**Economic and Social Council**Distr.: General
24 August 2012

Economic Commission for Europe**Inland Transport Committee****World Forum for Harmonization of Vehicle Regulations****158th session**

**1958 Agreement – Consideration of draft amendments
to existing Regulations submitted by GRSG****Proposal for the 04 series of amendments to Regulation
No. 46 (Devices for indirect vision)****Submitted by the Working Party on General Safety Provisions***

Figures 8c and 8d
Larger field of vision on the passenger side

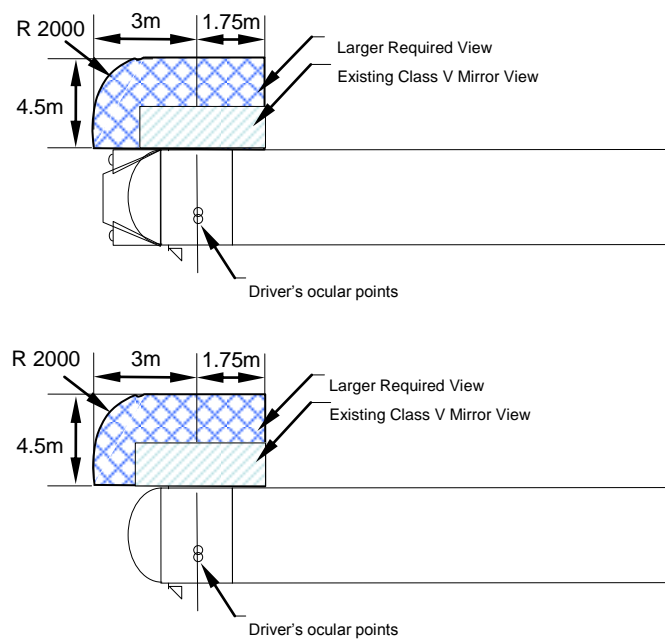
Insert new paragraphs 15.2.4.5.6. to 15.2.4.5.13. (including new Figures 8c and 8d), to read:

- "15.2.4.5.6. On the passenger side only, the field of vision shall also be such that the driver can see a flat horizontal portion of the road along the side of the vehicle which is outside the field defined in paragraphs 15.2.4.5.1. to 15.2.4.5.4. but within the field bounded by the following vertical planes; the front of this field of vision may be rounded off with a radius of 2,000 mm (see Figures 8c and 8d):

- 15.2.4.5.7. In the transverse direction, the parallel plane passing at a distance of 4.5 m in front of the plane mentioned in paragraph 15.2.4.5.1.
- 15.2.4.5.8. To the rear, the plane parallel to the vertical plane passing through the driver's ocular points and situated at a distance of 1.75 m behind that plane.

- 15.2.4.5.9. To the front, the plane parallel to the vertical plane passing through the driver's ocular points and situated at a distance of 3 m in front of that plane. This field of vision may be partially provided by a front mirror (Class VI).

- 15.2.4.5.10. The field of vision prescribed in paragraphs 15.2.4.5.6. to 15.2.4.5.9. may be partially provided by a 'wide-angle' exterior mirror (Class IV) or a combination of a close-proximity exterior mirror (Class V) and a front mirror (Class VI).

- 15.2.4.5.11. The area prescribed in paragraphs 15.2.4.5.6. to 15.2.4.5.9. may be viewed using a combination of direct view and indirect vision devices.

- 15.2.4.5.12. Paragraphs 15.2.4.5.6. to 15.2.4.5.9. shall not apply to a vehicle where no part of the mirror, or its holder, is less than 2.4 m above the ground, regardless of its position after adjustment.

- 15.2.4.5.13. Paragraphs 15.2.4.5.6. to 15.2.4.5.9. shall not apply to a vehicle of category M₂ or M₃.

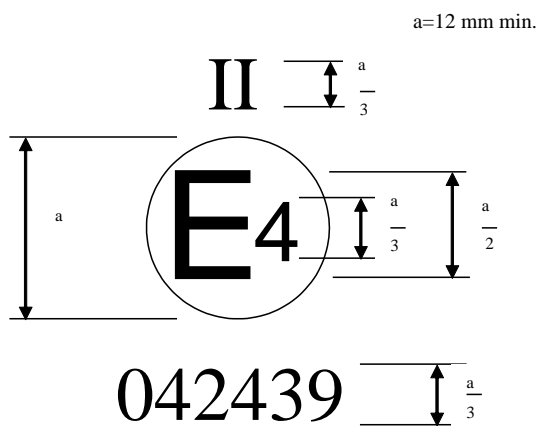
Annex 5, the figure and the caption under the figure, amend to read:

The above approval mark affixed to a device for indirect vision indicates that the mirror is a rear view mirror, of Class II, which has been approved in the Netherlands (E 4) pursuant to Regulation No. 46 and under approval number 042439. The first two digits of the approval number indicate that Regulation No. 46 already included the 04 series of amendments when the approval was granted.
